# ADA Curb Ramp New Construction Inspection Form (Perpendicular)

Nw 287 ave

24952.54

Nw Shaddon st

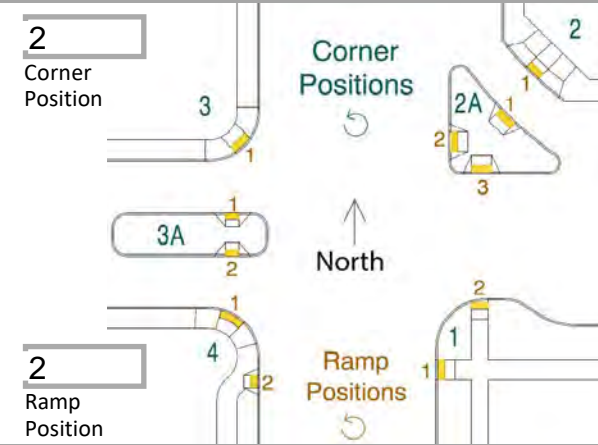
6 ≤ |5.0%| ☐ >|5.0%| ☒

3.5 ≤ 2.0% ☐ >2.0% ☒

RR1 ICRR turn space position area of differential settlement
